City of Mississauga Department Comments

Date Finalized: 2023-04-05 File(s): A725.22

The applicant requests the Committee to approve minor variances to allow a wider driveway and walkway proposing:

Property Address: 3164 Countess Crescent

Appendix 1 – Transportation and Works Comments

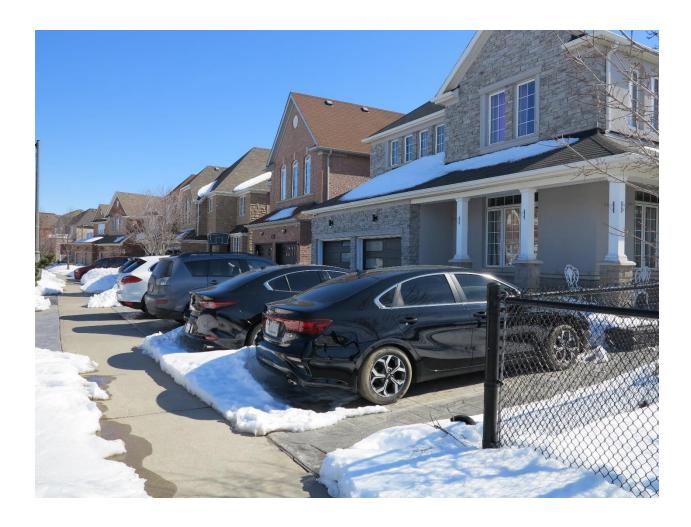
We note that in our previous comments we indicated that the submitted Proposed Site Plan (DWG No A-002) was not acceptable to this Department and that further modifications would be required. The applicant has submitted a revised Site Plan (November 20, 2022 revision date) which depicts a significant area to be re-instated to sod, both on private property and the city boulevard area. We are advising that we find the revised proposal acceptable provided that the required re-instatement is done in accordance with the revised drawing submitted.
